**Modification Notice – Type II Van cable anchored seat buckle end.**  
We are requesting that you replace the cable style buckle with the web strap assembly provided.

**Modification Notice – Type II Van cable anchored seat buckle end.**

Tether

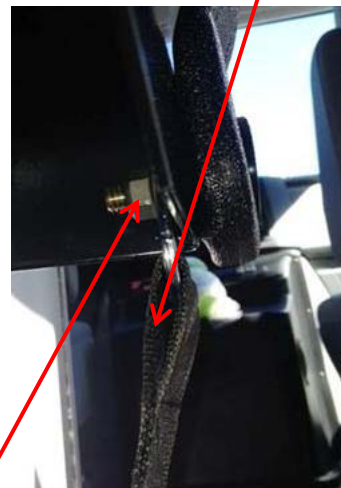
The three pictures below show a **Pedestal Style Base** which utilizes a Tether Strap attached to the Base. (See pictures below) This tether must be re-attached when replacing the cable style buckle end. After removing the installation bolt and the cable buckle end, re-attach the new webbed buckle using the flat washer and the connecting bracket for the Tether Strap. Both pieces will assemble behind the base with the installation nut. (NOTE) – When using a stover type prevailing torque nut and bolt please ensure the nut is completely seated prior to applying 28-32 foot pounds or torque. Please discard the old cable style buckle. If you have any questions call 800-374-9749.
